Technical Service Bulletin

01 MIL on with hissing noise, DTC P227900 is stored in the ECM

01 21 95 2054795/2 January 12, 2021. Supersedes Technical Service Bulletin Group 01 number 19-15 dated April 23, 2019 for reasons listed below.

Figure 1. Oil fill extension tube (see possible cross-threading at number 7 on diagram).

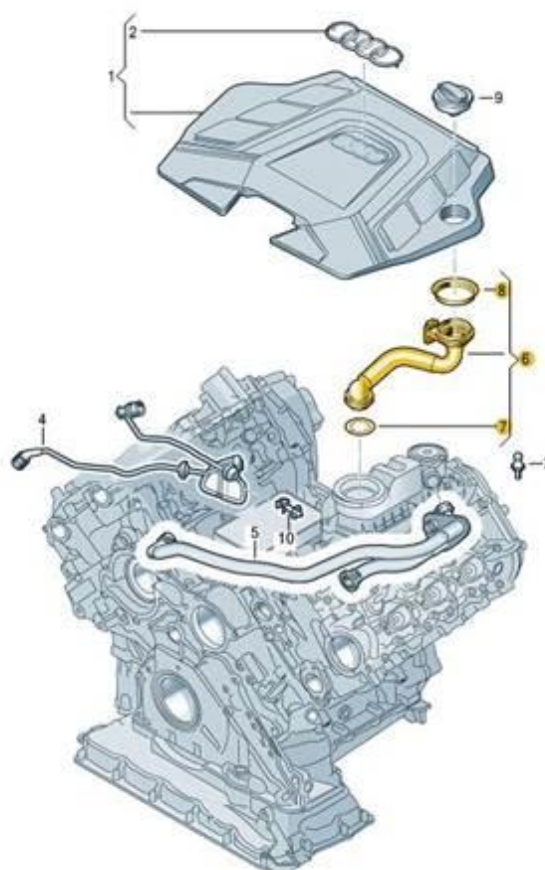
During assembly, the oil fill extension tube (Figure 1) may have been assembled incorrectly. If this extension tube is cross-threaded, an intake/vacuum leak may be generated at the interface between the extension tube and the valve cover (Figure 1, 7).

To improve the assembly, the oil fill extension tube has been geometrically optimized and improvements in the assembly process were implemented.

If an intake/vacuum leak is suspected, please inspect this component and verify proper sealing. If any components are damaged from cross threading, replace as necessary.
